## COMMERCIAL TRAINING TOOLBOX TIPS

### Blower Bearing Set Screws

Applies to Lennox Energence, Strategos, Landmark, and Raider Rooftop Units 3-6 tons

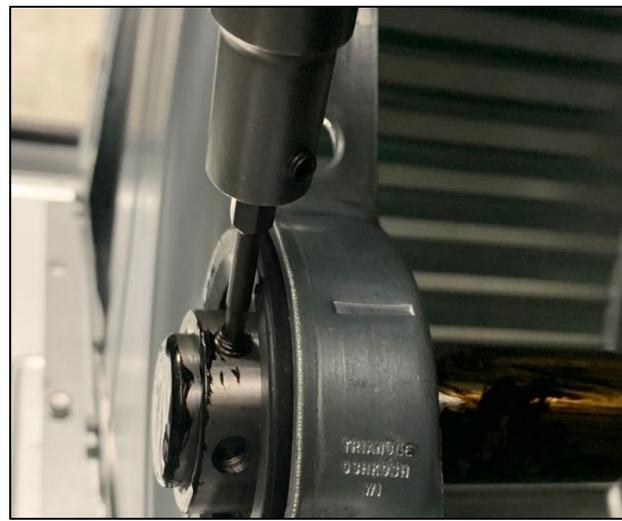
Some 3 to 6-ton Energence, Strategos, Landmark, and Raider units may have blower bearing set screws which did not receive the full specified torque of 80-inch pounds, beginning with July 2020 production of these units thru April 2021. Serial numbers begin with 5620FXXXXX to 5621DXXXXX.

Lennox recommends checking these set screws for tightness as part of the initial unit start up and during seasonal maintenance checks.
